To: Portsmouth Zoning Board of Adjustment (“ZBA”)
From: R. Timothy Phoenix
Date: April 27, 2022
Re: I. Request for Amendment to Plans in Support of Zoning Relief Granted June 16, 2020 (LU20-164)
II. Request for One Year Extension of Zoning Relief Granted June 16, 2020.
Owner: London Bridge South, Inc., Owner/Currier Homes of Windham, LLCJ Applicant

Property Location: 114 Saratoga Way, Units 1-4
Tax Map 212 Lots 112 and 113, GRB Dist.

I. REQUEST FOR AMENDMENT

TITLE	SITE PLAN for 114 SARATOGA WAY Tax Map 212, Lot 112 Portsmouth, NH
OWNER OF RECORD	LONDON BRIDGE SOUTH INC 273 CURRIER RD CANDIA, NH 03034
RUB NUMBER	22-023
DWG. NO	2 OF 10
ISSUE	9

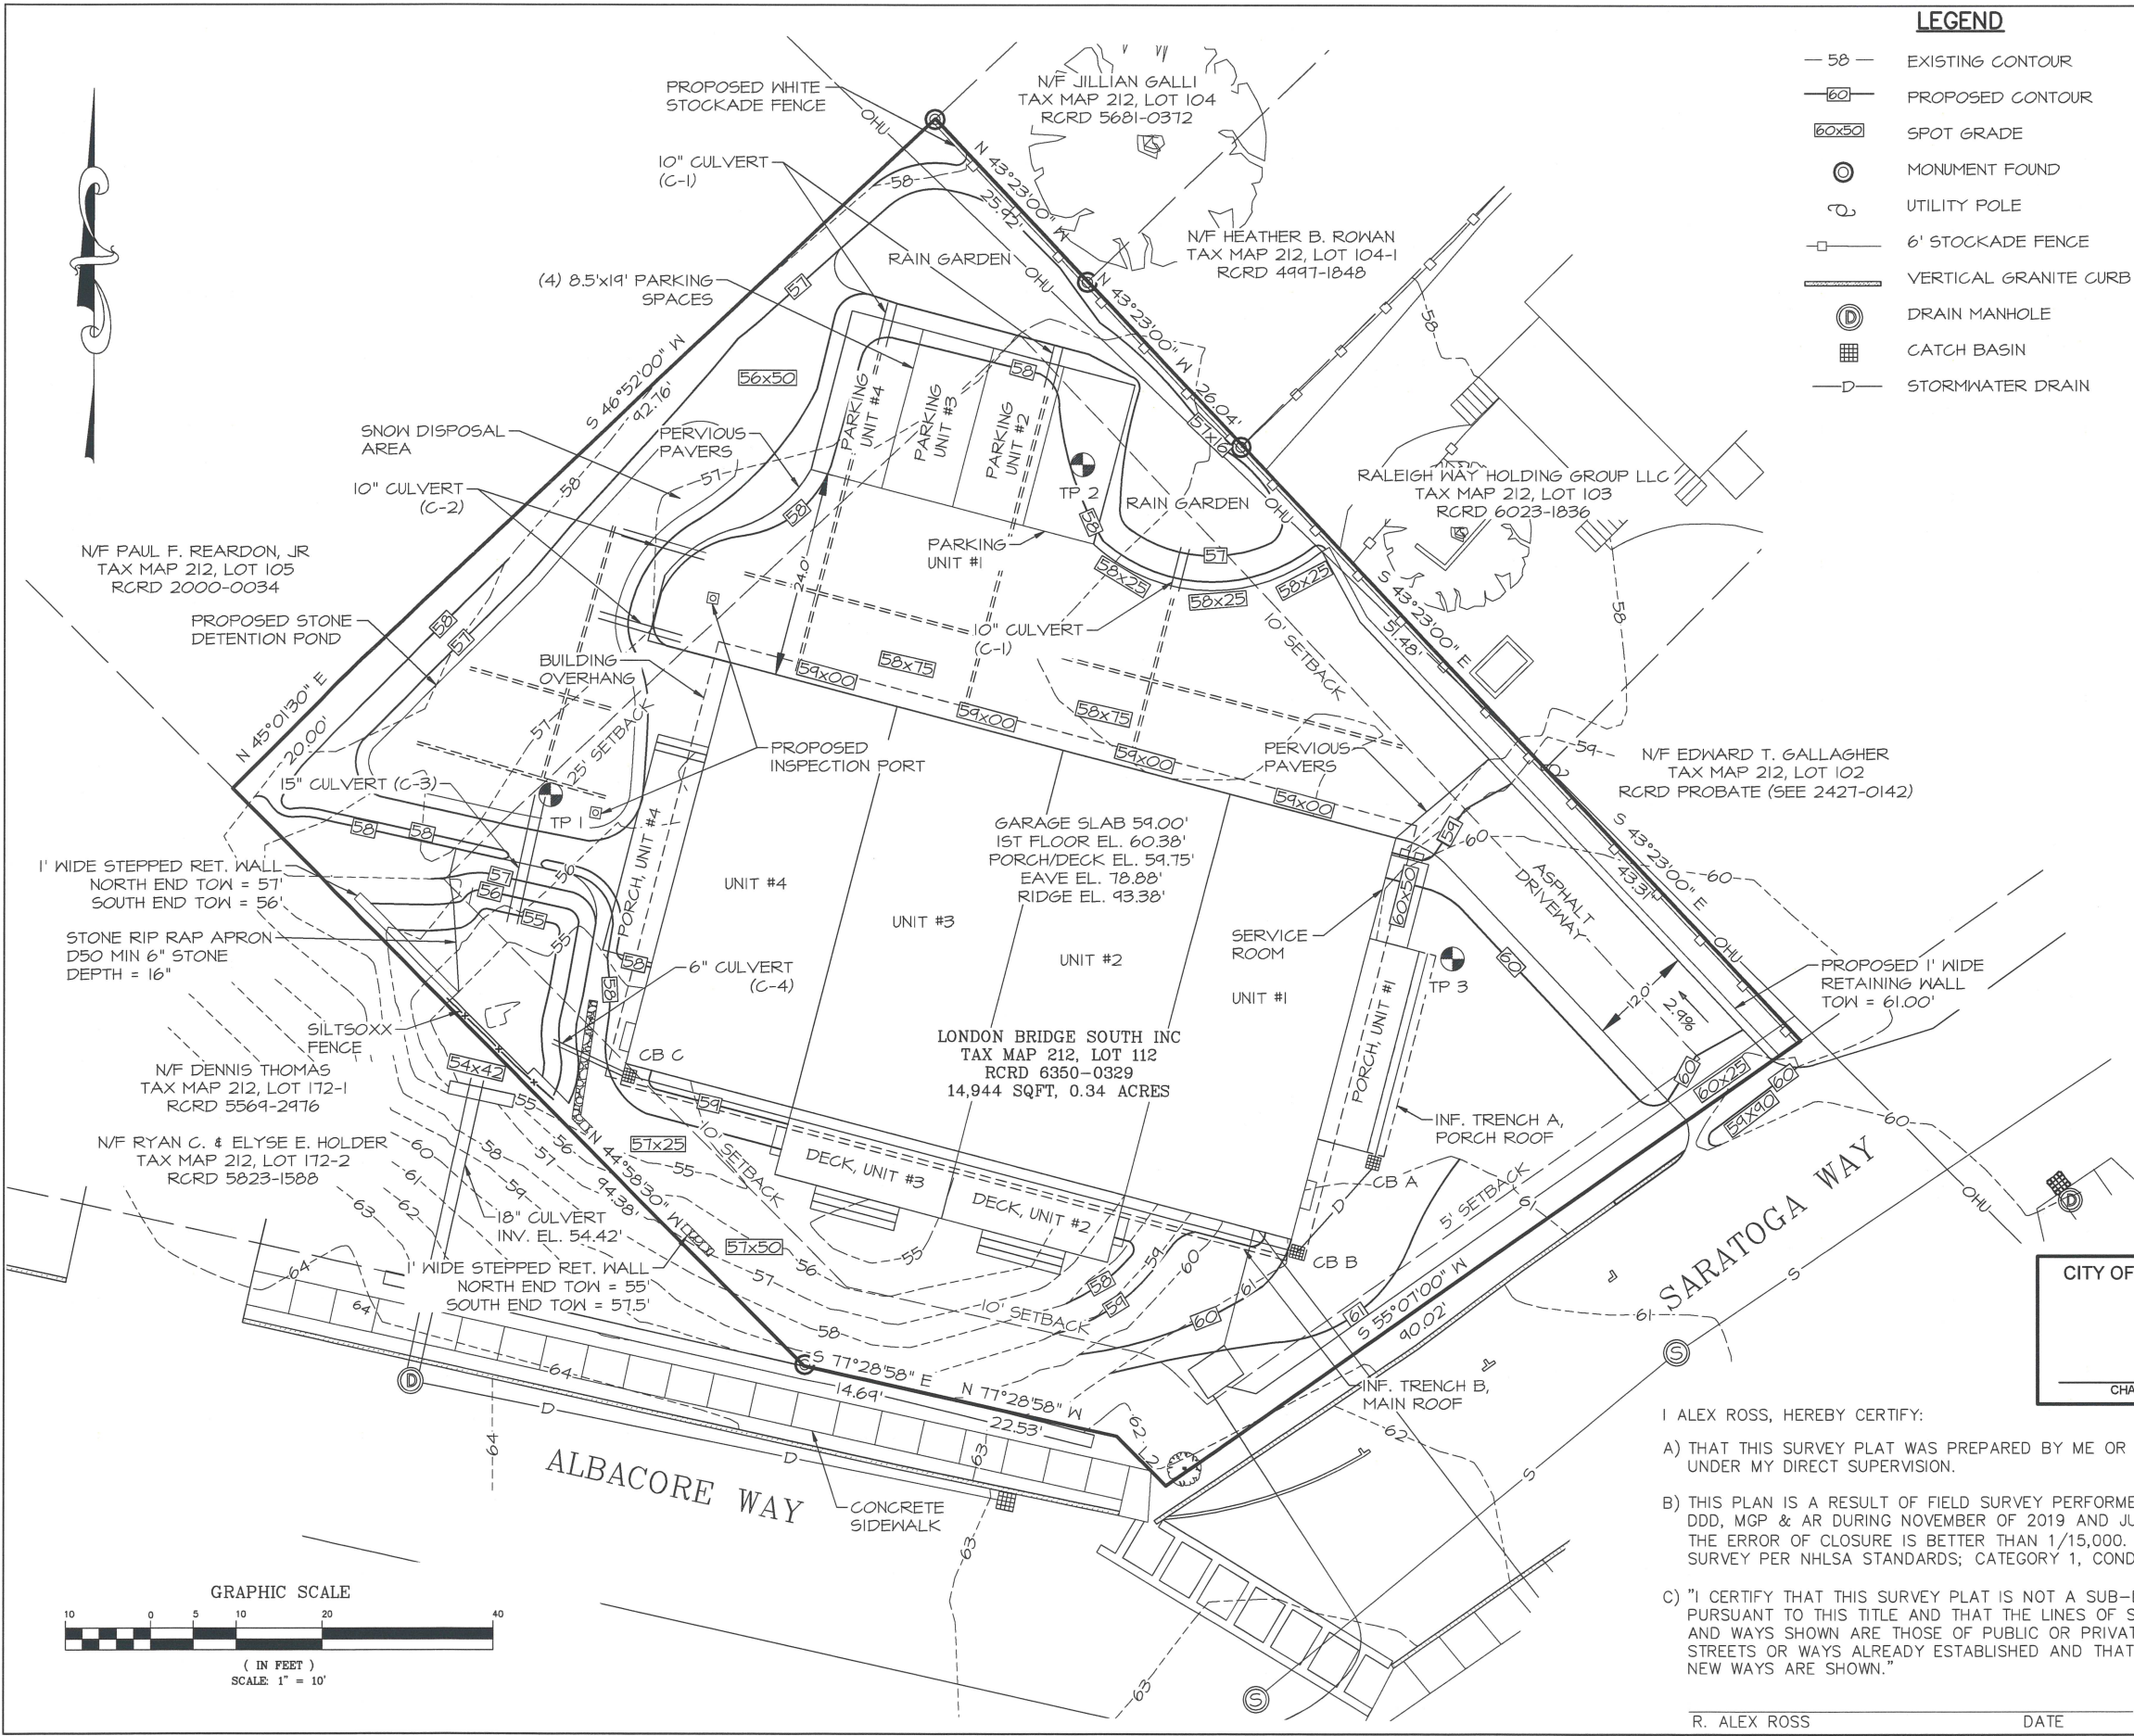
- Third-floor dormer added to approved building creates +/- 140 s.f. additional floor area to interior units.
- Site plan amendments providing for fence and new utilities/room location.
- Side indents decreased to 1 foot to alleviate odd access to stairwells and bathroom areas and improve structurability. This added 8 s.f. per end unit and 0 s.f. for interior units.
- Front and back walls moved to line up with first-floor exterior wall for aesthetics, less stringent structural requirements, and to accommodate two panel egress windows in place of casement windows.
- Stone and new siding choices for exterior finish, remove some windows to better accommodate energy code.
